April 21, 2020

RE: WAP-20-01/WRG-20-01/MIS-20-01/LLA-20-01

Please accept this letter and the accompanying materials as our complete response to the City's February 5, 2020 determination that our application was incomplete (see Attachment J). We believe the materials provided herein fully respond to the incompleteness items outlined in the City's letter and provide the necessary basis to deem the application complete. We look forward to continuing to work with City staff on any design and associated issues, as necessary, during the review and approval process.

**PRELIMINARY CUT AND FILL MAP
 9TH STREET
 CONSOLIDATED LAND USE APPLICATION
 WEST LINN, OREGON (TAX LOT 802 TAX MAP 3 1E 2AC)**

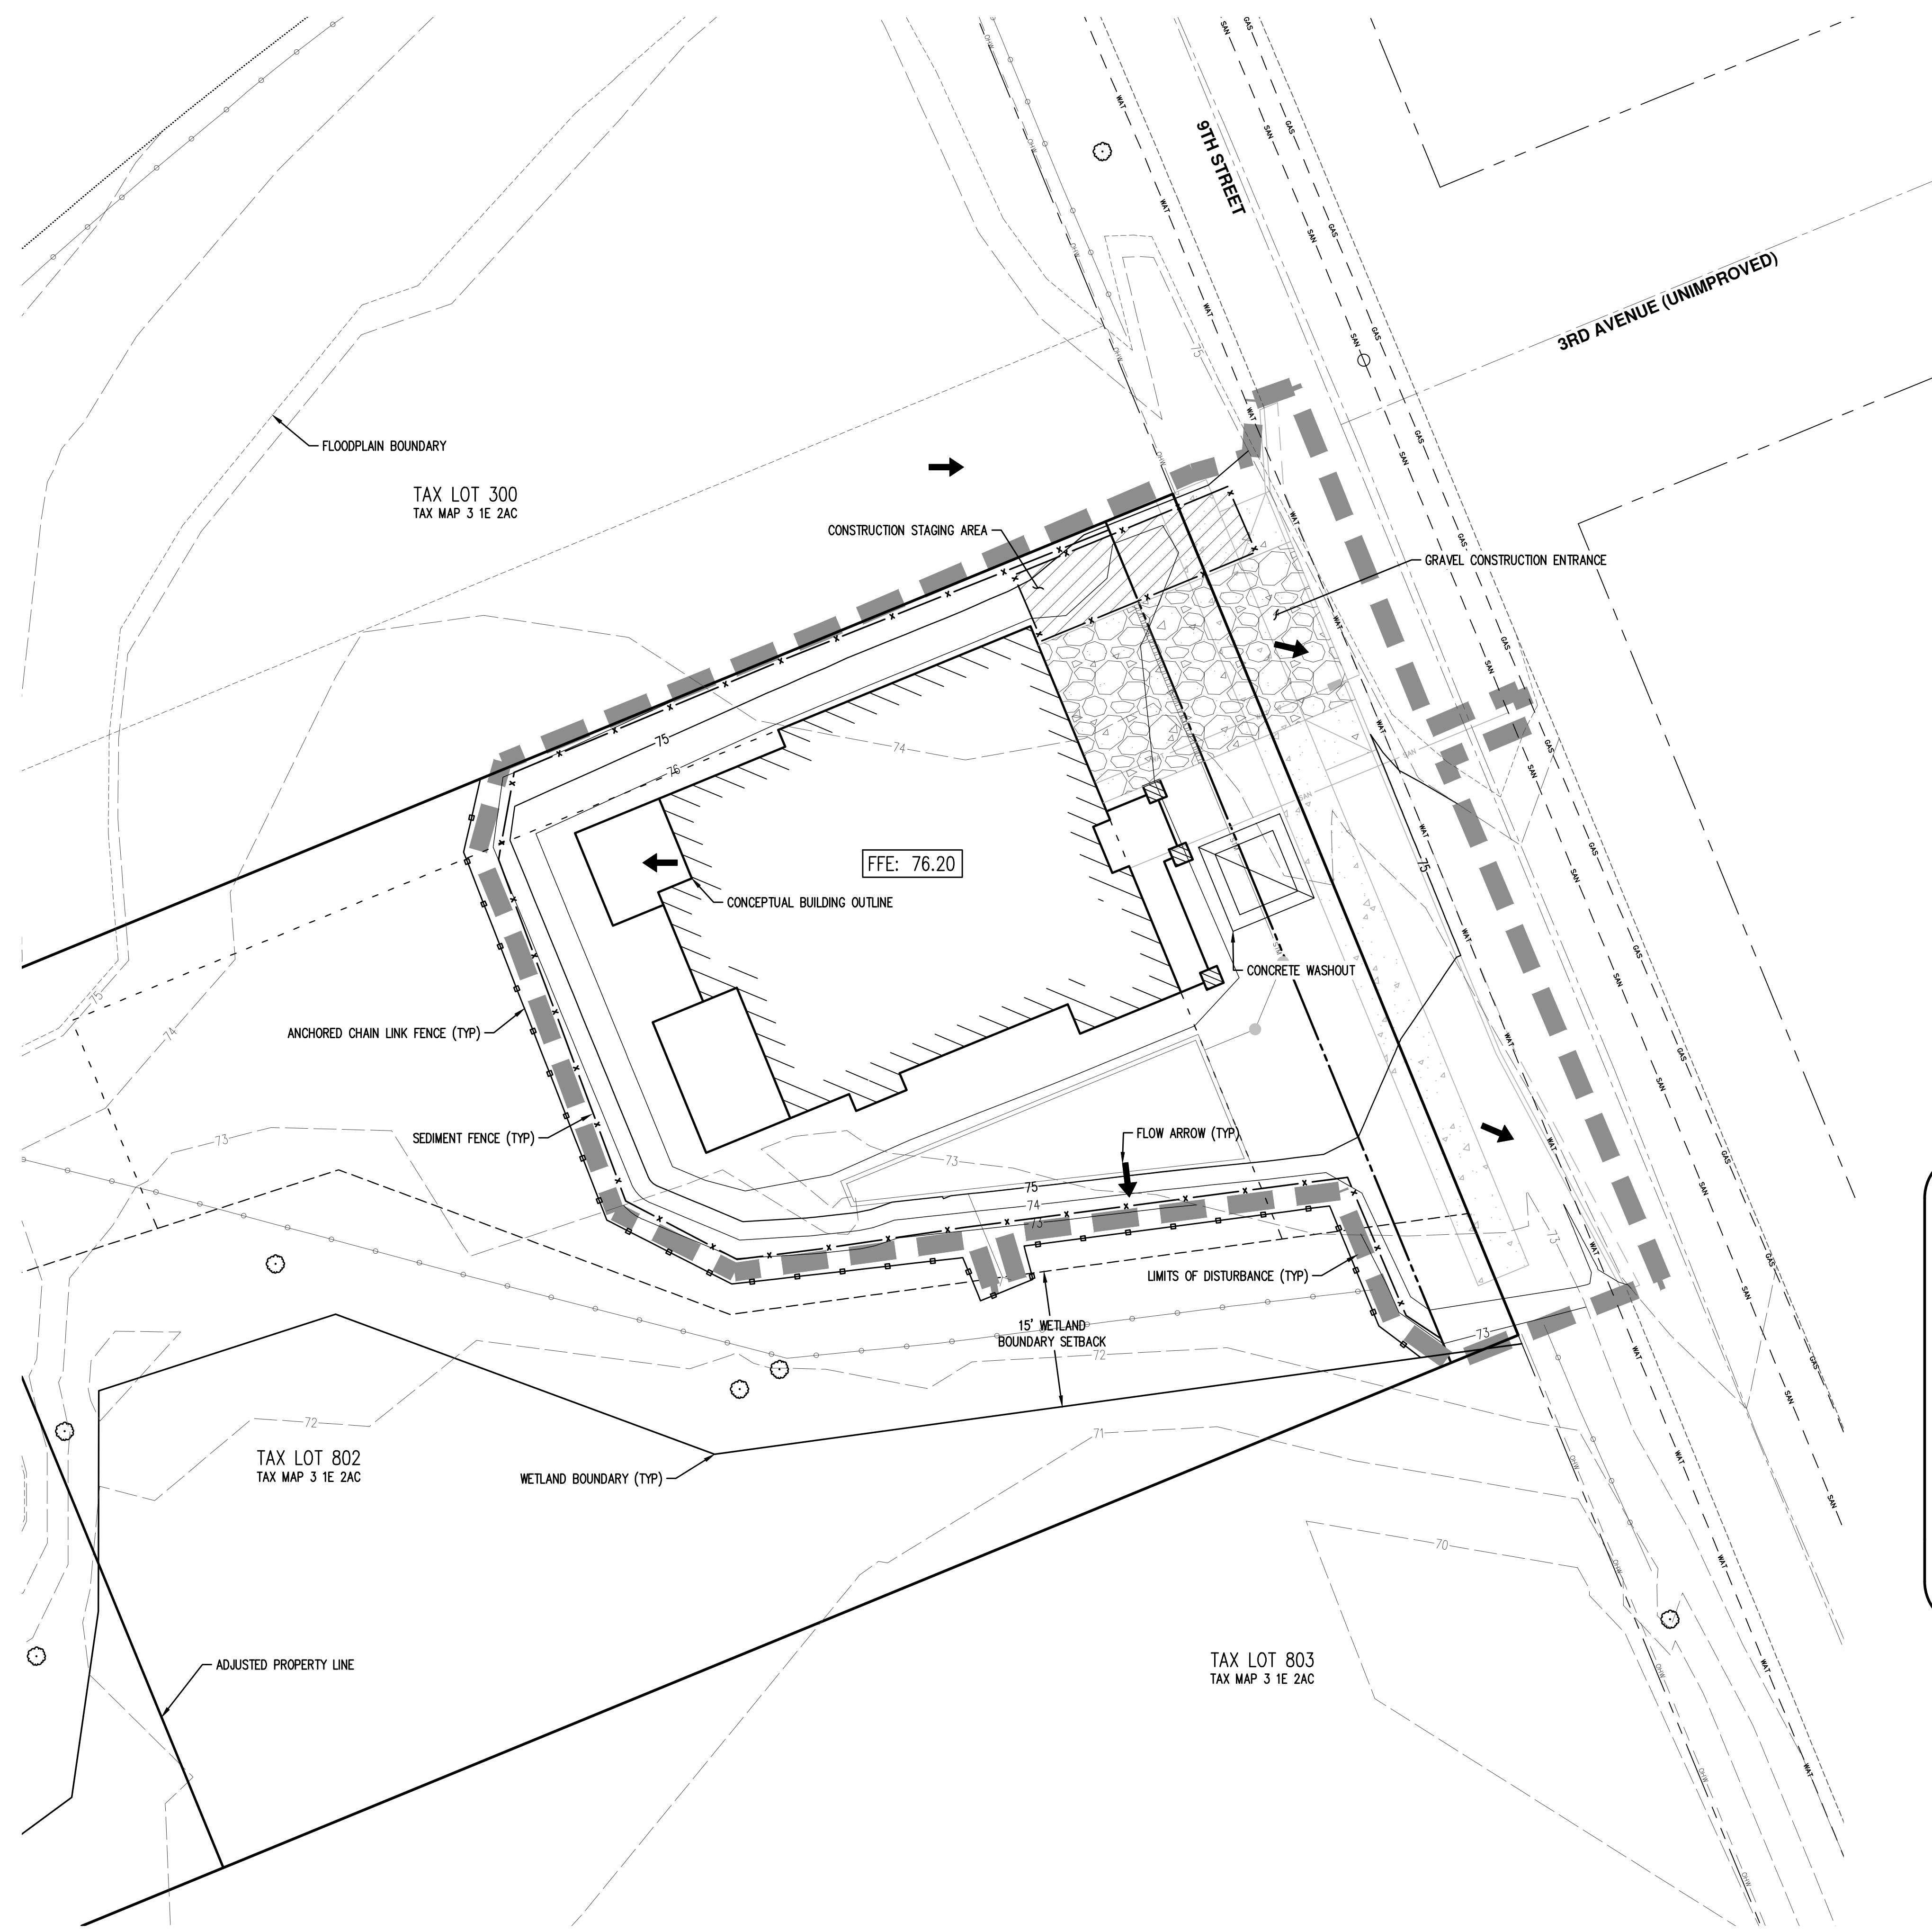
4. CDC Chapter 27.050(D) – Map of proposed alteration. Please provide a map that illustrates the location of all cuts and fills, including the total quantity of each.

Response: Attachment C, Sheet P05 includes a map of the location of all cuts and fills, including the total quantity of each. This criterion is met.

CONSTRUCTION MANAGEMENT PLAN
9TH STREET
CONSOLIDATED LAND USE APPLICATION
 WEST LINN, OREGON (TAX LOT 802 TAX MAP 3 1E 2AC)

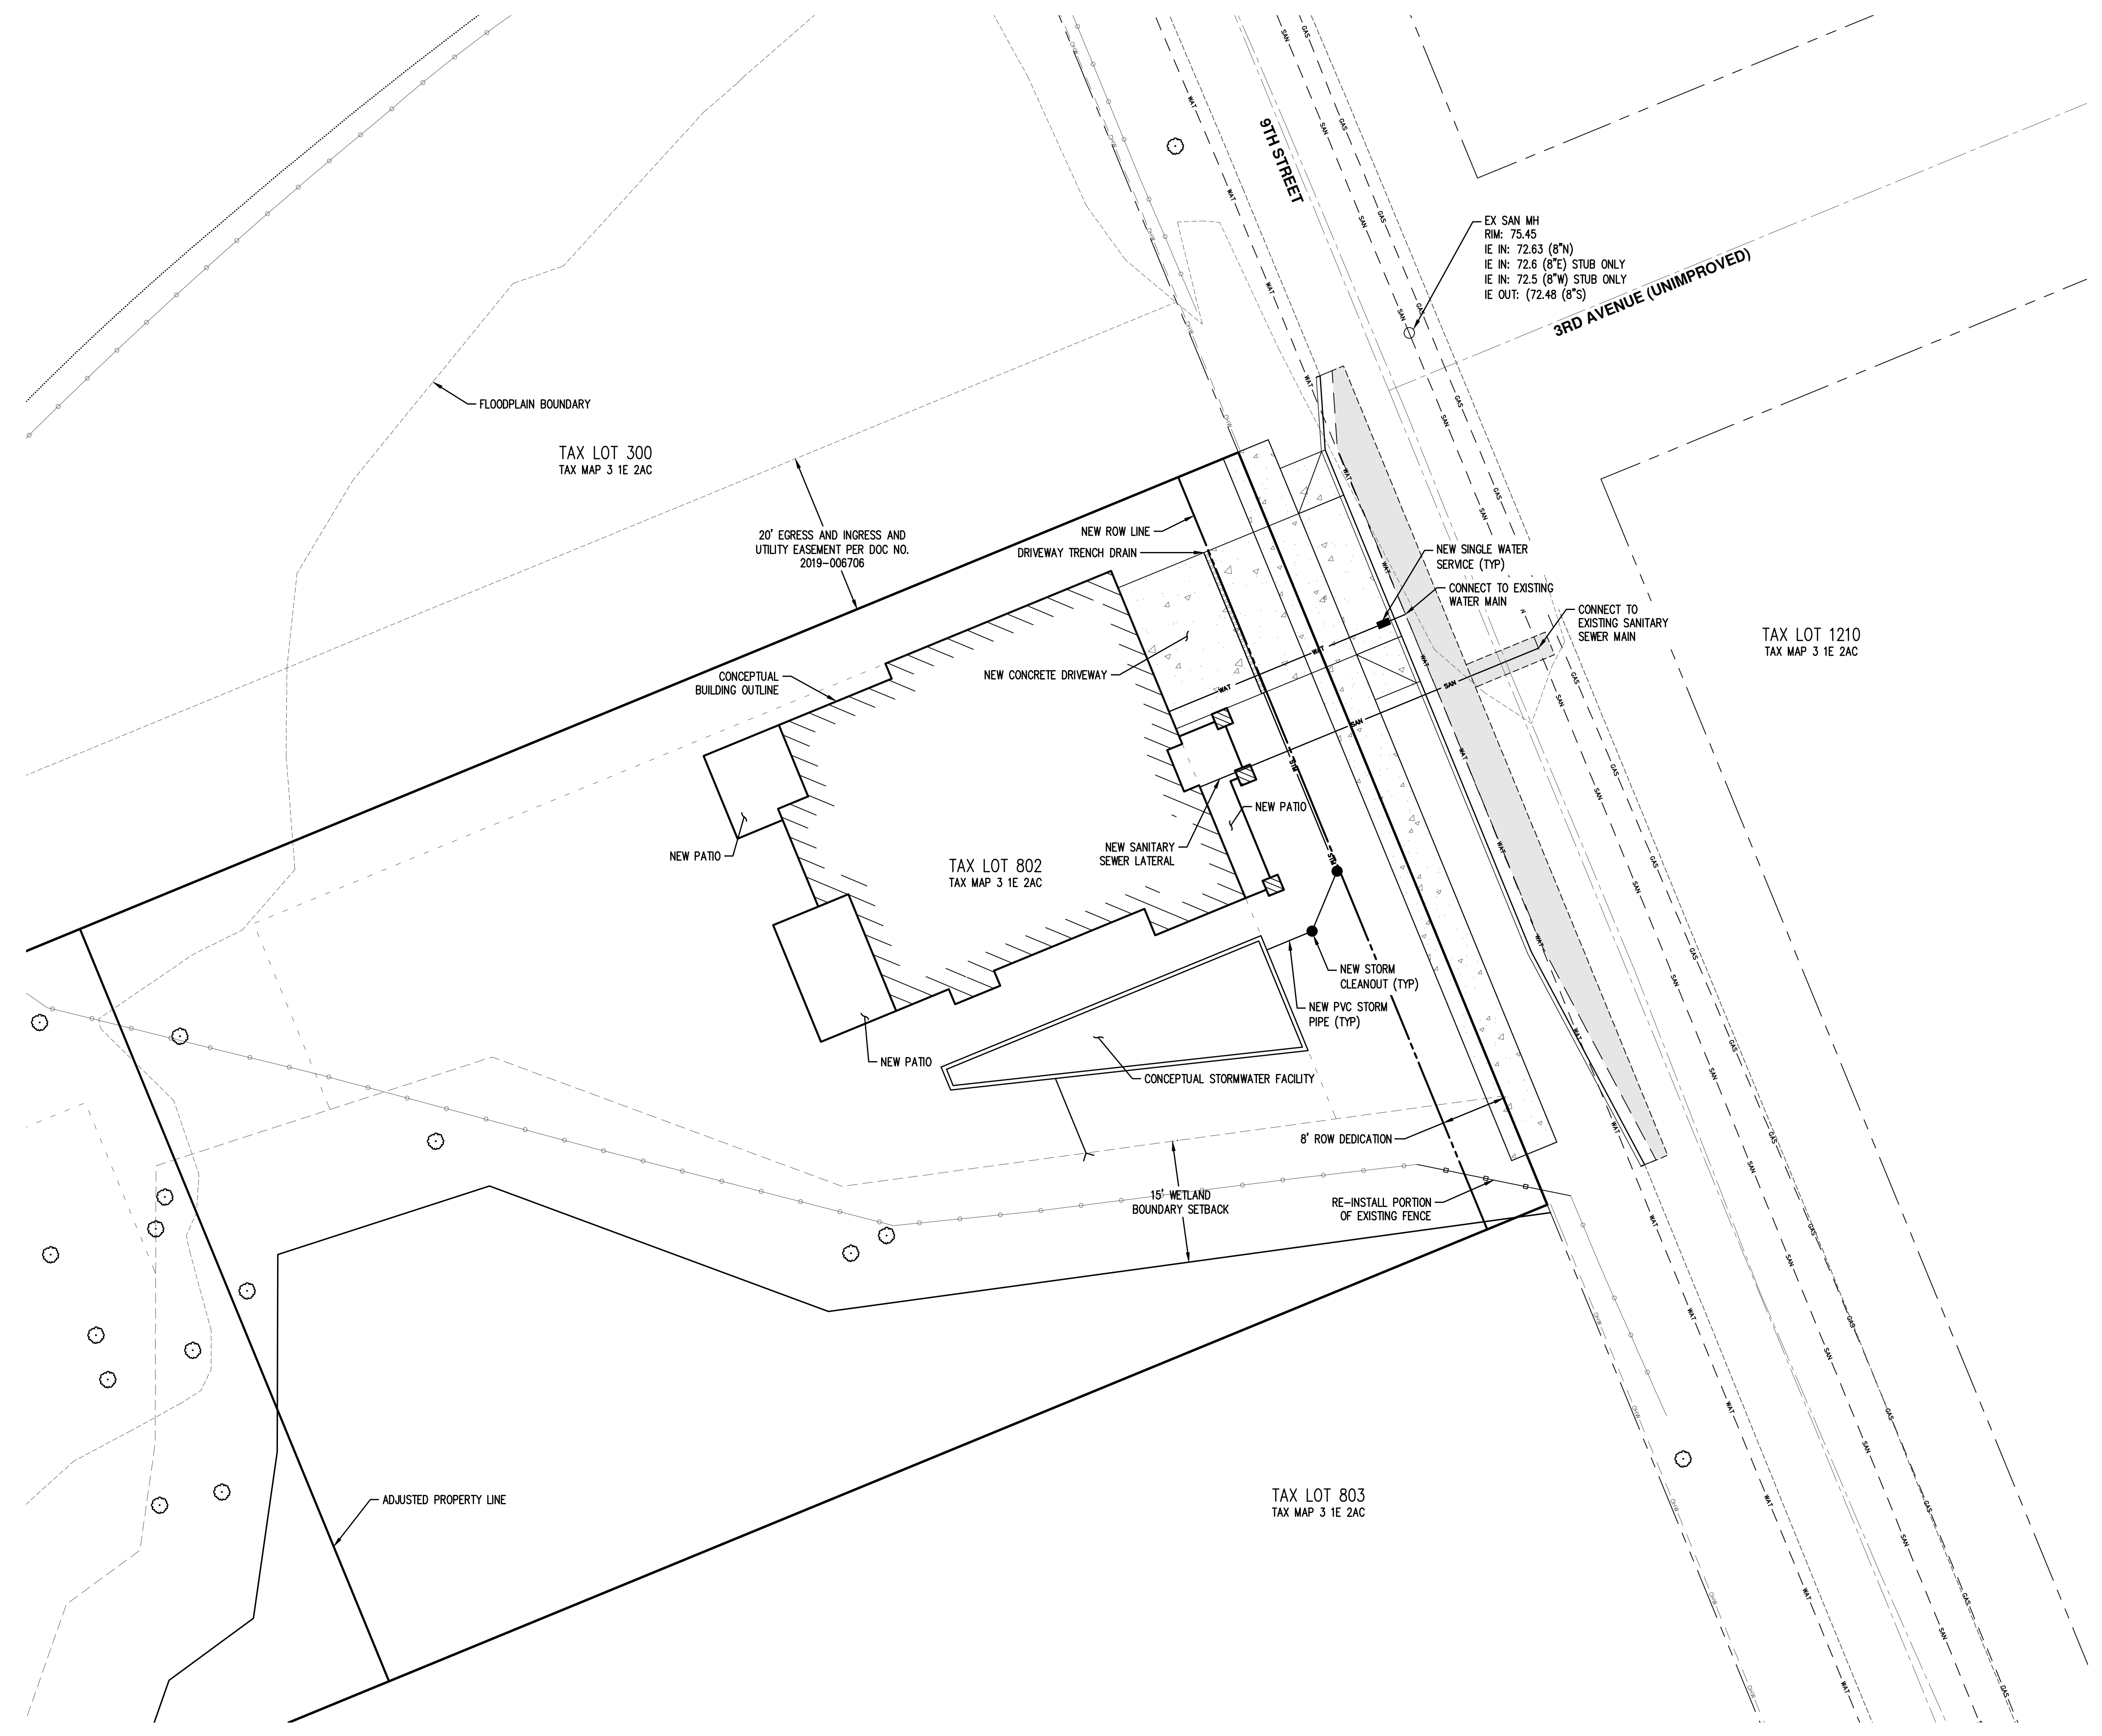
10. CDC Chapter 32.050.G(3) – Anchored Chain Link Fence. Please update Site Plans to show appropriate protection fencing for the WRA.

Response: The revised Construction Management Plan included as Attachment C, Sheet P06, illustrates the anchored chain link fence around the WRA. This criterion is met.
